**Subject:** Submittal of Replacement Pages to Update the NAC-UMS<sup>®</sup> FSAR from Revision 4 to Revision 5 (Docket No. 72-1015)

**10 CFR 72.48 Evaluation Summary Report**

**NAC-UMS<sup>®</sup> Universal Storage System  
(Docket No. 72-1015)**

PROJECT 790 DRAWING 595 REV 10

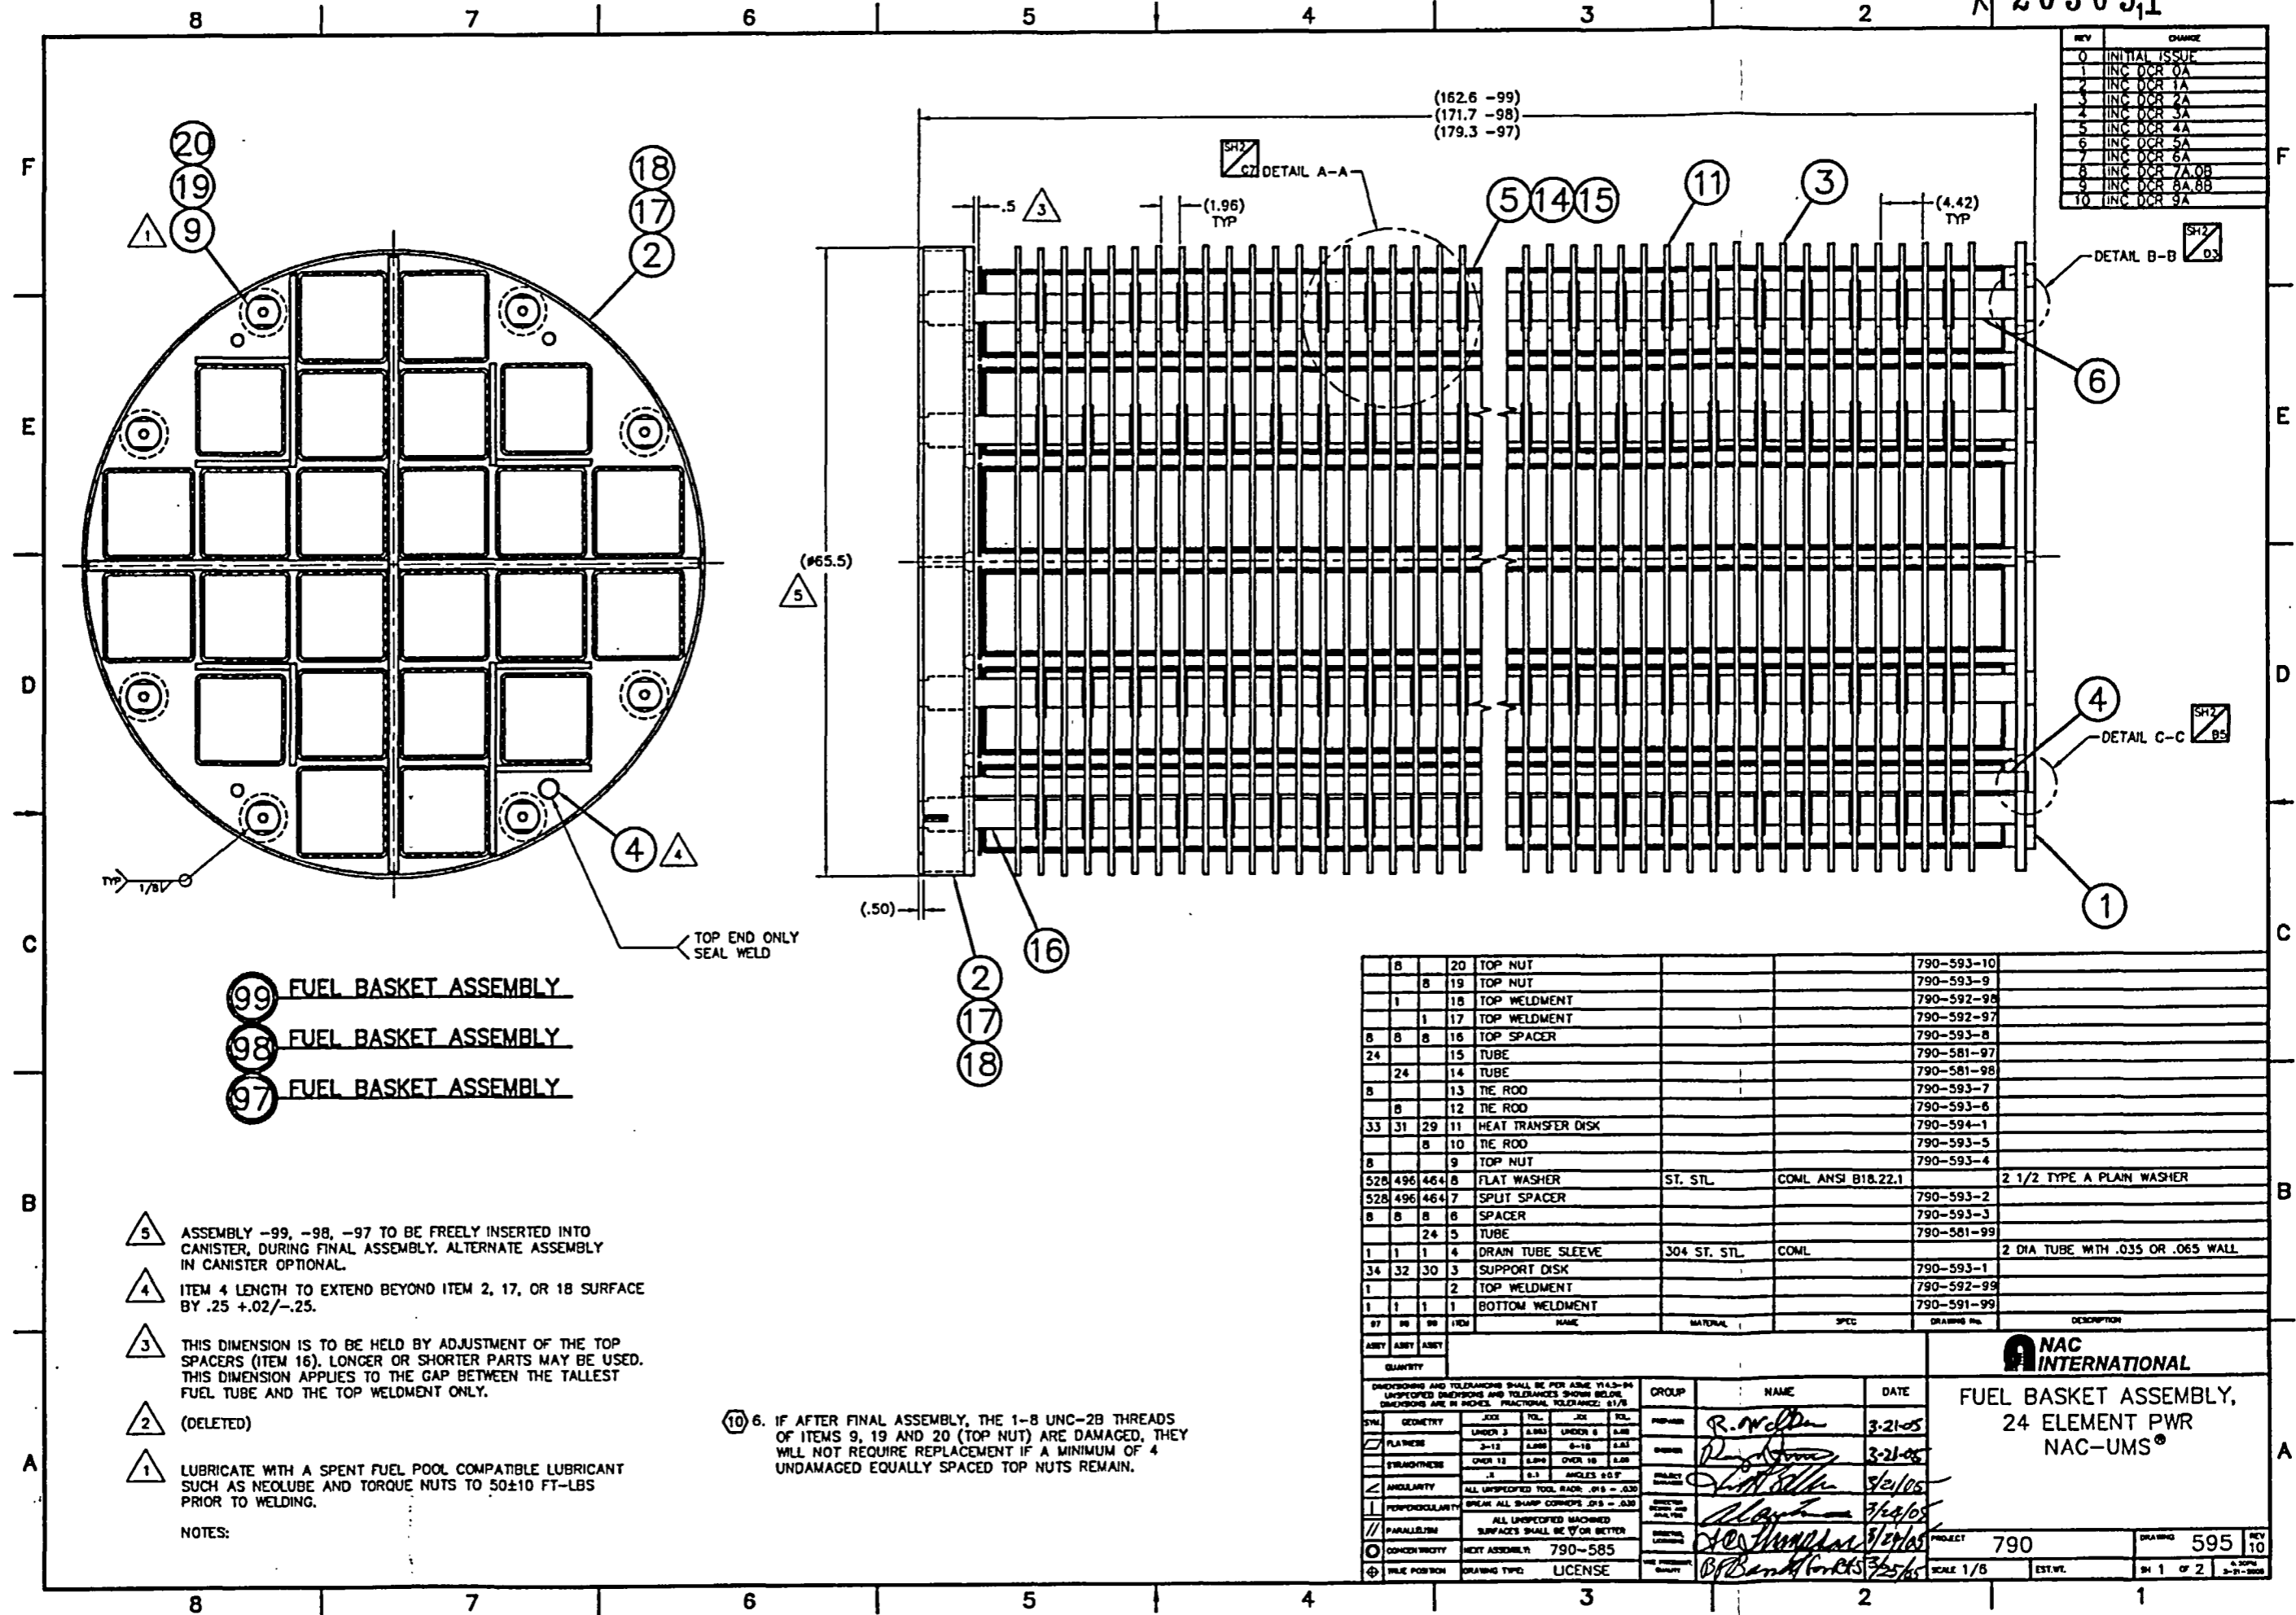
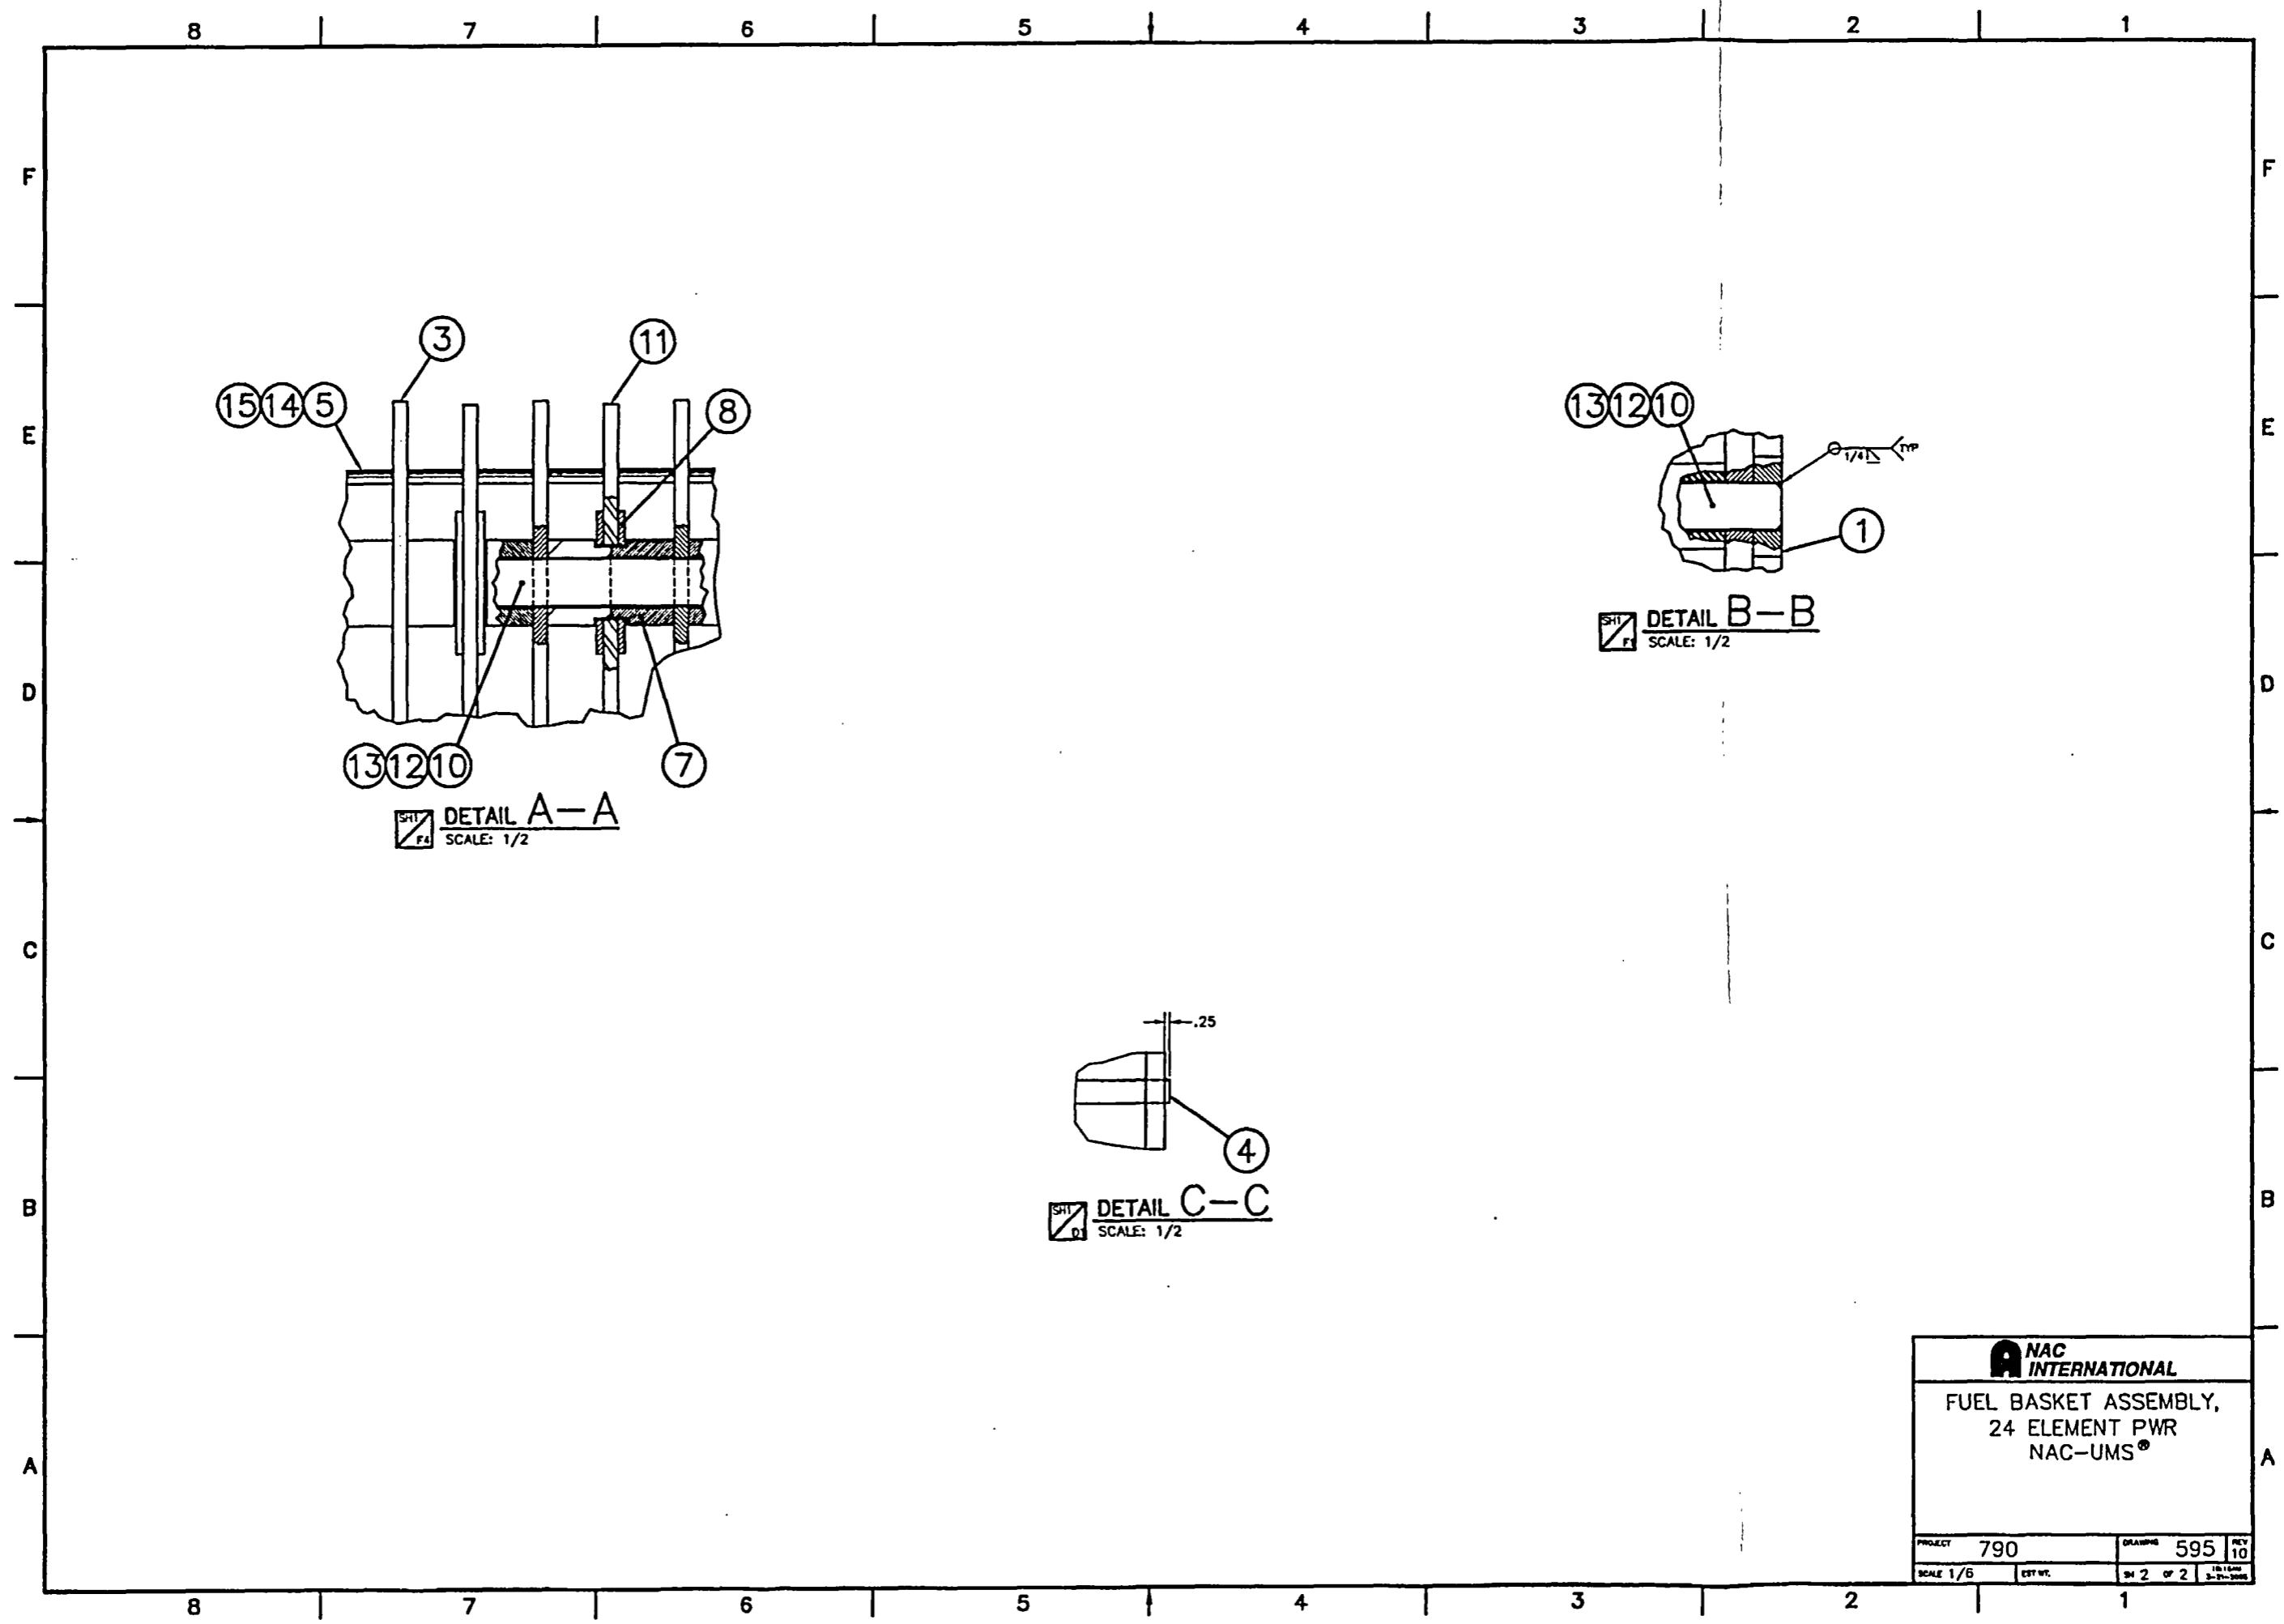
Changed drawing Note 6 to read, "...Items 9, 19 and 20 (top nut)...."

This change is an editorial update to drawing note 6. The intent was not to limit this specific configuration to only being applicable to one basket assembly and one specific Top Nut, but rather to all assemblies and all Top Nut configurations. This DCR(L) brings the drawing current with all the final as-built deviations noted in the site documentation packages for the Maine Yankee project.
